IN THE UNITED STATES PATENT AND TRADEMARK OFFICE

Applicant : Wolfgang Henke et al.  
Applic. No. : 10/637,193  
Filed : August 8, 2003  
Title : Method for the Characterization of an  
Illumination Source in an Exposure Apparatus

REQUEST TO APPROVE DRAWING CHANGES

FIG 1

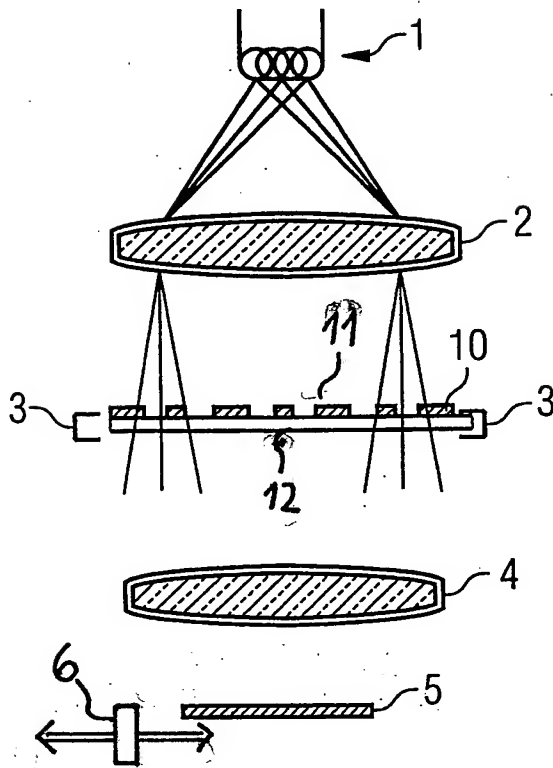
This preliminary amendment is filed to designate the sensors mentioned on page 17 of the specification with reference numeral 6. Accordingly, Fig. 1 is amended as well to show the sensors illustrated with reference numeral 6 and to add reference numerals 11 and 12 thereto. A *Request to Approve Drawing Changes* is attached hereto.

Enclosed please find two (2) sheets of drawings. In the informal drawing of Fig. 1, the changes are highlighted in yellow. Specifically, reference numerals 11, 12 and the sensors 6 were added. These changes are formalized in the attached formal drawing. Approval of the changes is respectfully requested.
